**Request for Additional Information No. 335 (4059, 4061)  
Question 03.08.04-10, Revision 2**

**U. S. EPR Standard Design Certification**

**Question 03.08.04-10:****Follow-up to RAI Question 03.08.04-5**

**Table 03.08.04-10-1—Transnuclear Whole Pool Analysis and U.S. EPR Maximum Wall/Slab Average Pressures**

**Figure 03.08.04-10-1—Hydrodynamic Pressure on SFP Walls due to Seismic Load in -Z (vertical down) Direction**

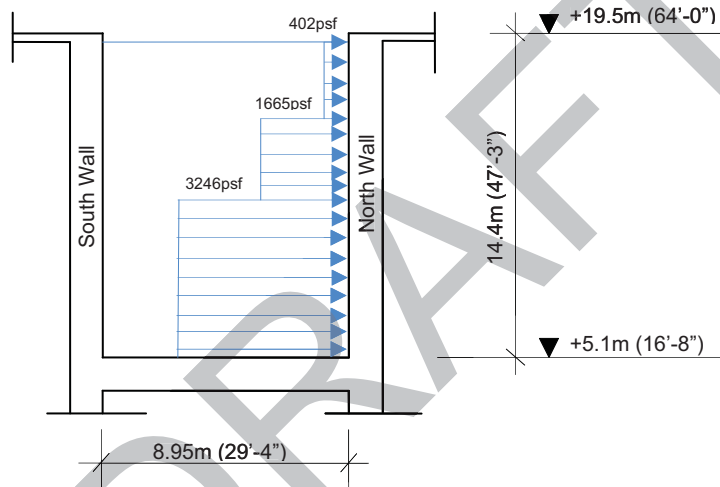
Since the spent fuel storage racks are free-standing, and their analysis and design is deferred to the COL application, AREVA at this stage needs to clarify how they determined the loads imposed on the spent fuel pool. Both the procedure to determine the loads and the magnitude of these loads (e.g., sliding, rocking, twisting, impact on the pool walls and slabs) need to be described. This information should be included in the relevant sections of the FSAR so that, when the detailed design of the storage racks is actually carried out, the COL applicant can perform the necessary comparison between the assumed loads and the loads obtained from the detailed analysis. The applicant is requested to describe the analysis and procedures for the spent fuel pool and racks, and explain how they compare to the criteria in Appendix D to SRP Section 3.8.4, "Guidance on Spent Fuel Pool Racks." Include this information in the FSAR.

In addition, describe the specific procedures used to determine the seismic forces on walls and slabs due to water in the pool. In this regard, FSAR Section 3.8.4.4.1, item "Hydrodynamic Loads" states that for the static FE model of the Nuclear Island structure:

Elaborate on how the hydrodynamic loads are determined and provide a summary of the relevant calculations for the spent fuel pool. This summary should include the magnitude of convective and impulsive masses, corresponding frequencies, and a description of the methodology used to convert the dynamic effects of these water masses to loads applied to the static FE model. Confirm if the same methodology is used for the other seismic Category I pools in the U.S. EPR.

The SFP water loads used in the NI static analysis consist of hydrostatic and hydrodynamic forces applied in the ANSYS model as pressure on the walls and pool slab. The hydrostatic pressure on the pool slab is 2932 psf. The hydrostatic pressure on the walls is gradually increased to a maximum of 2837 psf at the bottom of the SFP. The hydrostatic pressure on the slab is applied as uniform load, while the hydrostatic pressure on the walls is applied as triangular pressure load. The hydrodynamic loads on the SFP walls and slab are:

- Hydrodynamic pressure on SFP walls and slab resulting from seismic load in Z (vertical up and down) direction are calculated by multiplying the pool slab ZPA in the Z direction and the mass of the fluid. The SFP floor ZPA is conservatively taken to be an envelop of the entire floor ZPAs in Z direction at elevation +12.14 ft (+3.70 m) and 1.44 g. The magnitude of the calculated and applied uniform pressure on the pool slab is 4222 psf. The pressure on the walls is calculated using 3.28 ft (1m) increments and has a magnitude of 152 psf at the first increment near the water surface, and 4086 psf at the last increment at the bottom of the pool. The loads from each increment are separated into three bands, and the pressure is averaged over the band height, and applied as a uniform wall pressure over the band heights. Figure 03.08.04-10-1 shows the application of the uniform pressure on the walls in the static model.
